6.0 ADMINISTRATIVE CONTROLS

ROCHESTER GAS AND ELECTRIC CORPORATION GINNA STATION ORGANIZATION

Attachment B

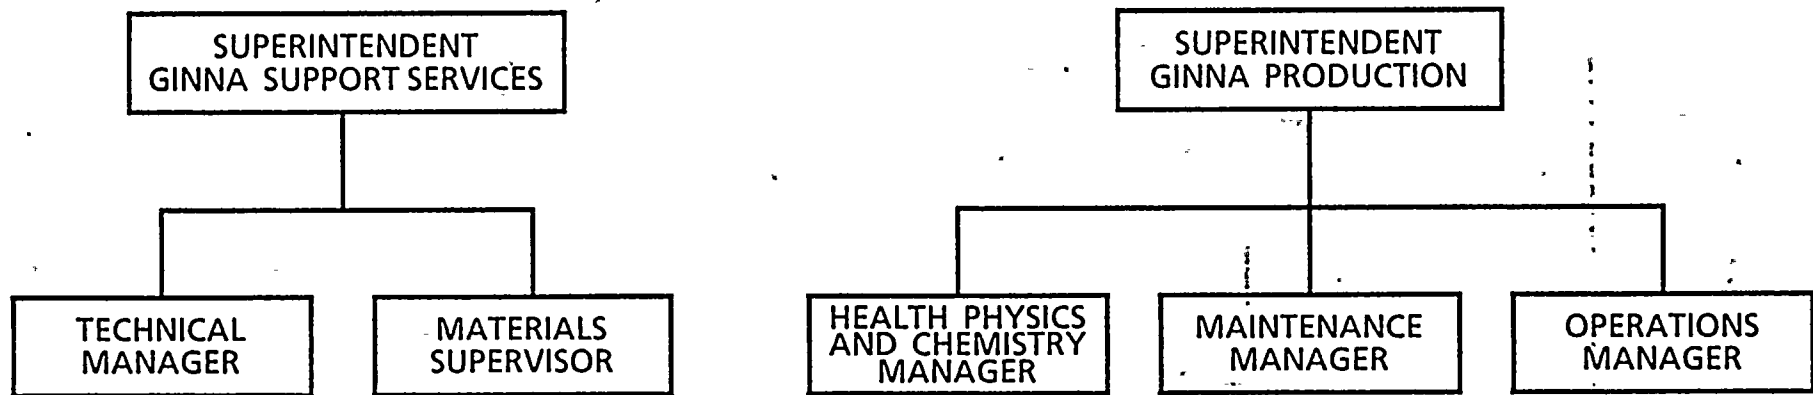
The proposed Technical Specification change reflects changes in the RG&E management organization and changes in the Ginna organization. Following the sudden death of the Senior Vice President, Operations, RG&E Management, with the concurrence of the Board of Directors, has decided not to fill this position. Under the new organization the vice presidents who had reported to the Senior Vice President, Operations, will now report directly to the President and Chief Operating Officer. The President of the Company has had an extensive involvement with the Ginna plant in various capacities since the time of construction.

A realignment of responsibilities in the Engineering organization has resulted in a change in title whereby the Engineering Department now reports to the Vice President, Engineering and Construction, and a position of Chief Engineer has been reinstated. The position of Assistant Chief Engineer, Engineering and Construction, has been replaced by the position of Director of Engineering Services. In order to maintain independence of the Quality Assurance organization from the design, construction and other engineering functions, the Executive Vice President will have overall responsibility and authority to direct Quality Assurance, however, the day-to-day direction will come from the Chief Engineer.

The position of Superintendent, Nuclear Production and Superintendent of Ginna Station has been changed to the position of Superintendent, Nuclear Production.

The position of Superintendent of Ginna Station has been divided into Superintendent-Ginna Production and Superintendent-Ginna Support Services. The Superintendent Ginna-Production is responsible for overall on-site Ginna Station operation.

The position of Assistant Superintendent has been eliminated.

Nuclear Assurance will report to the Superintendent, Nuclear Production.

Figure 6.2-2

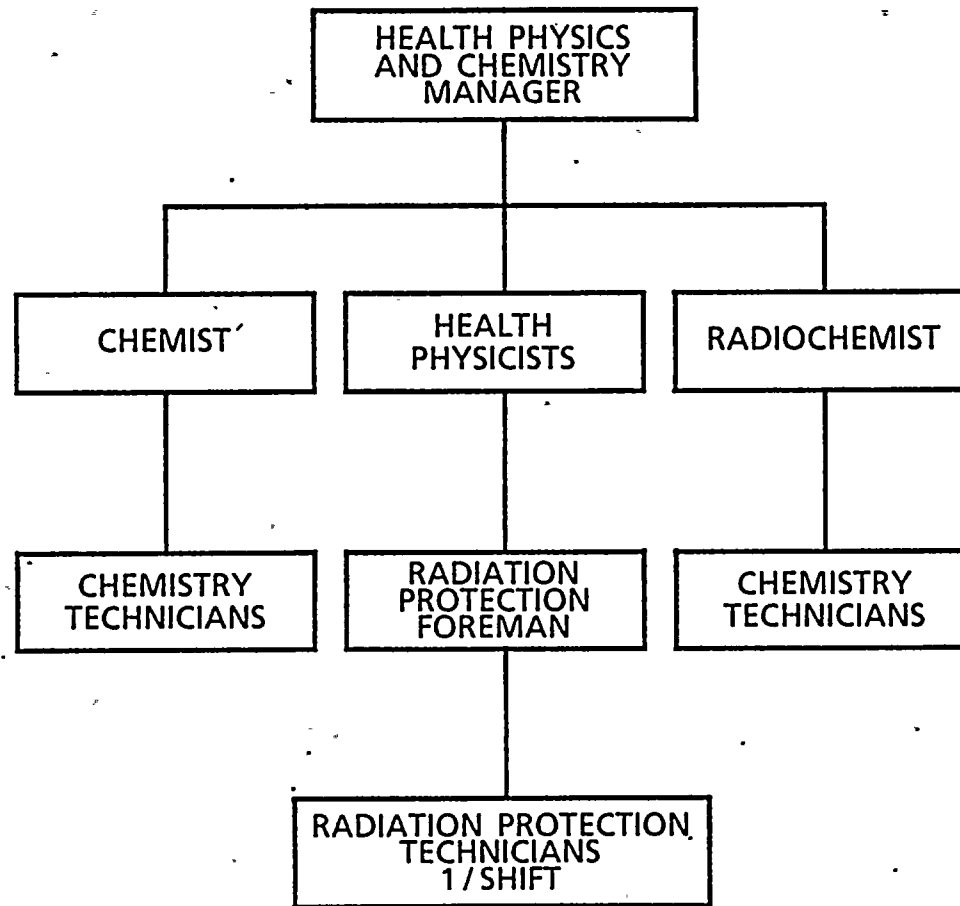
The Health Physics and Chemistry Manager, the Maintenance Manager, and the Operation Manager will report to the Superintendent-Ginna Production.

Minor changes have also been made under the various managers which is reflected in the figures.

Figure 6.2-3

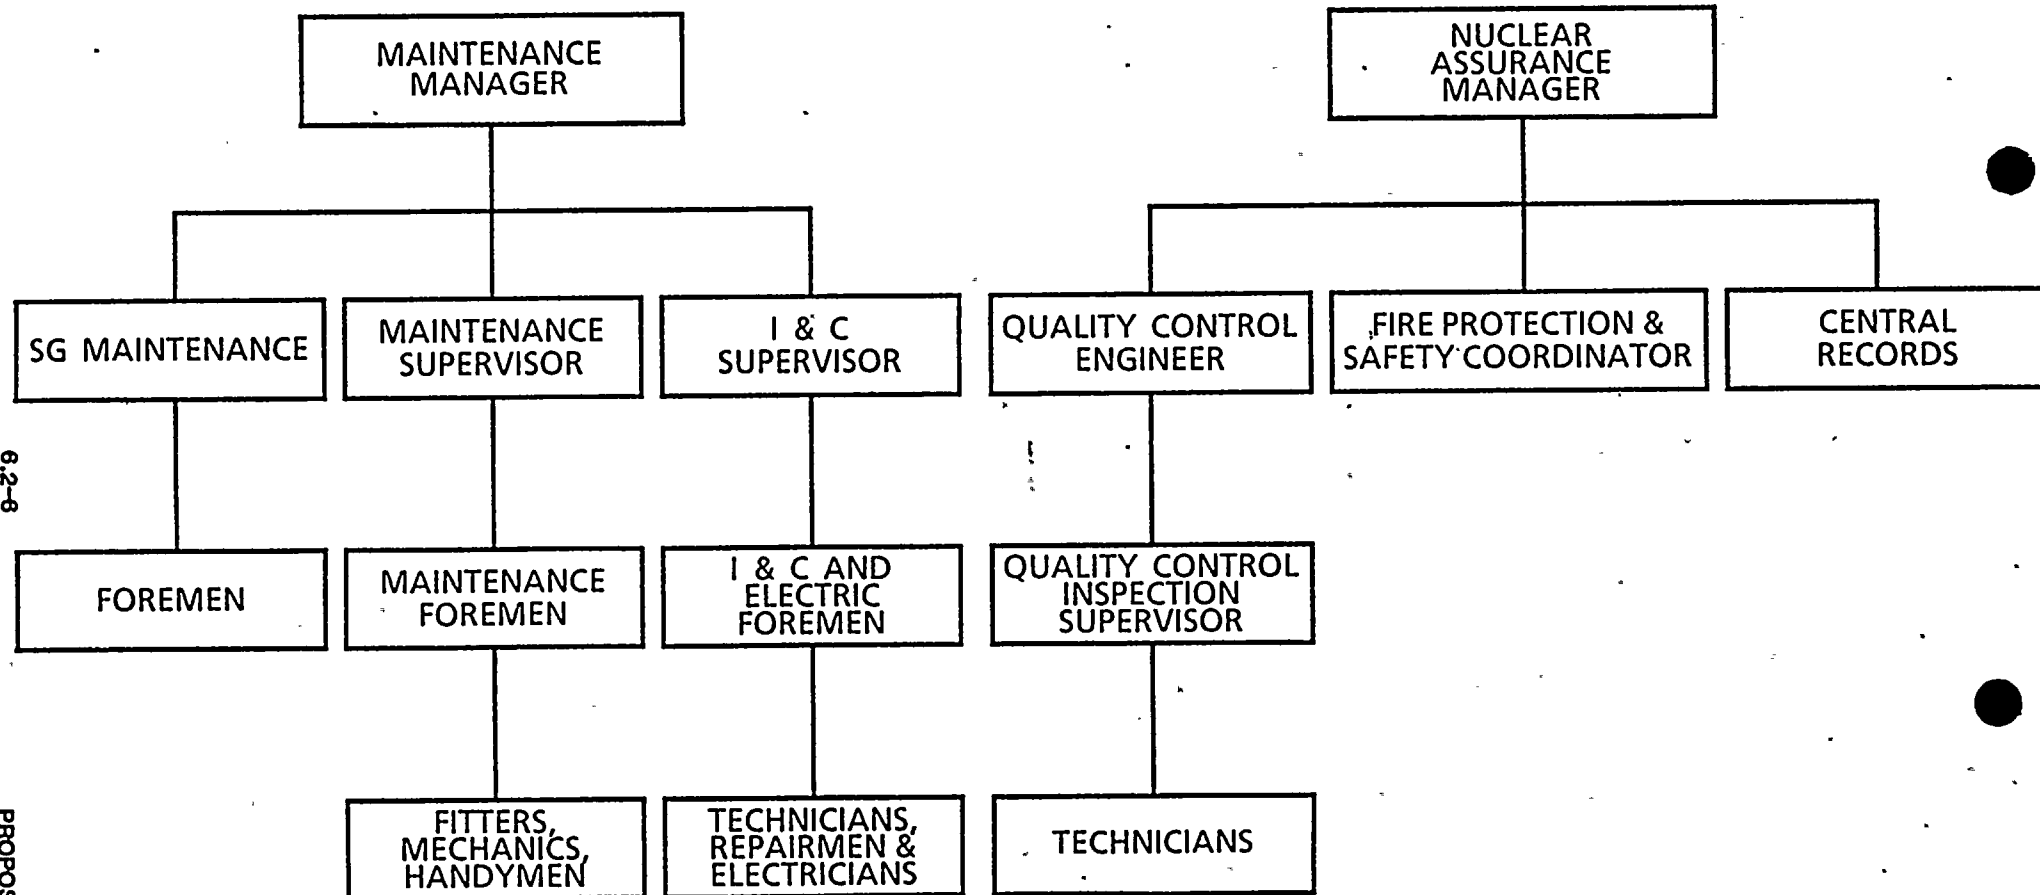
The removal of the communications path from the Quality Control Engineer to the Superintendent, Nuclear Production and Ginna Station Superintendent coincides with elevating the lead quality responsibility from the Quality Control Engineer to the Manager, Nuclear Assurance. This change is intended to enhance the Ginna quality program through reestablishing the direct reporting link to the responsible superintendent and through reassignment of a former experienced lead Quality Control Engineer as Manager, Nuclear Assurance.

Central Records will report to the Nuclear Assurance Manager.

Figure 6.2-4

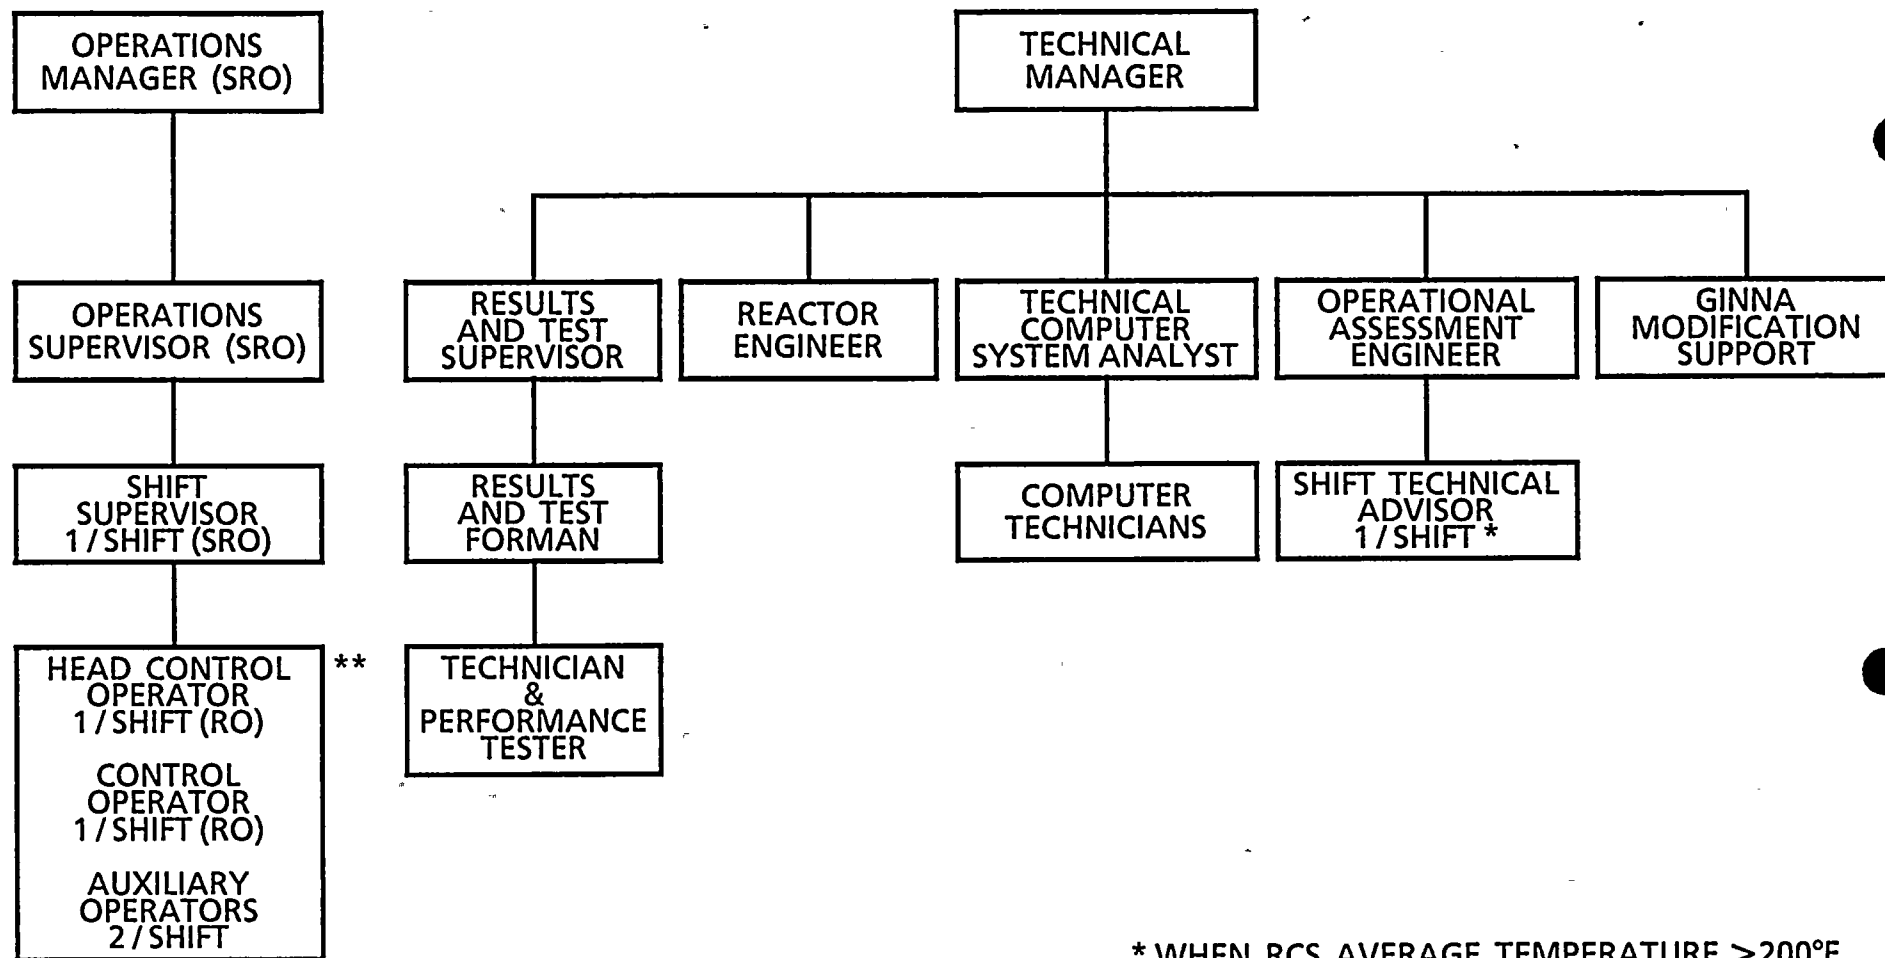
The Technical Manager and the Materials Supervisor will report to the Superintendent-Ginna Support Services.
